Access Compliance Report

Public Rights-of-Way

(Curb Ramps)

Intersection ID: 6882	Main Street: STATESVILLE_RD	Cross Street: CINDY_LN	Location: SE
ADA ID: E185A498E40A	Ramp Type: Perp	Initial Pass/Fail: Fail	Overall Compliance: No
Severity Score: 8.75			
Codes/Mitigation Info/Possible Solution		Field Measurements/Component Compliance

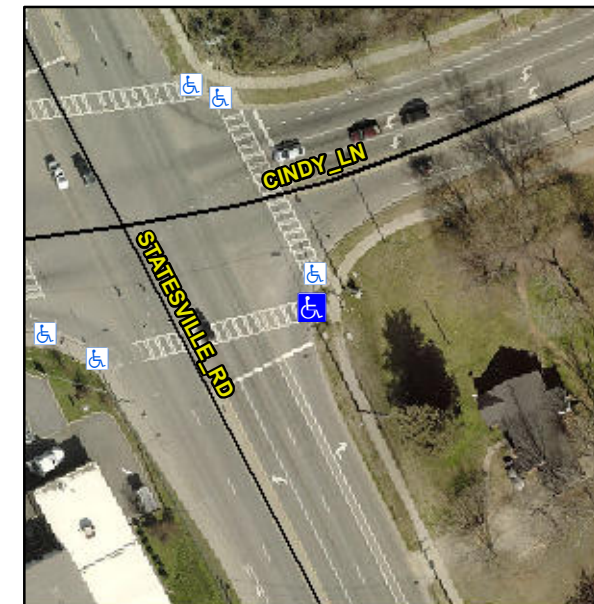
Not Found, R304.5.1

Compliance	Description	Data	Compliance	Description	Data
N/A	Ramp Length (in)	104.5	Yes	Ramp Slope (%)	7.6
No	Ramp Width (in)	36.5	Yes	Ramp XSlope (%)	0.9
N/A	Flare Type LT	N/A	N/A	Flare Type RT	N/A
N/A	Flare Slope LT (%)	N/A	N/A	Flare Slope RT (%)	N/A
N/A	Flare Traversable LT?	N/A	N/A	Flare Traversable RT?	N/A
N/A	Landing Length (in)	N/A	N/A	DWS Provided?	N/A
N/A	Landing Width (in)	N/A	N/A	DWS Contrast?	N/A
N/A	Landing Slope (%)	N/A	N/A	DWS Length (in)	N/A
N/A	Landing X Slope (%)	N/A	N/A	DWS Full Width?	N/A
N/A	Landing Curb? (Y/N)	N/A	N/A	DWS Offset (in)	N/A
N/A	Shared Landing?	N/A			
N/A	Gutter Ponding?	N/A	N/A	Gutter Slope (%)	N/A
N/A	Gutter Lip Ht (in)	N/A	N/A	Gutter X Slope (%)	N/A
N/A	Painted X Walk1?	Yes	N/A	Painted X Walk2?	N/A
	X Walk 1 Direction	To W		X Walk 2 Direction	N/A
N/A	X Walk 1 Width (in)	112.0	N/A	X Walk 2 Width (in)	N/A
	X Walk 1 Slope (%)	0.9		X Walk 2 Slope (%)	N/A
	X Walk 1 X Slope (%)	0.3		X Walk 2 X Slope (%)	N/A

Remove & Replace Entire Ramp.
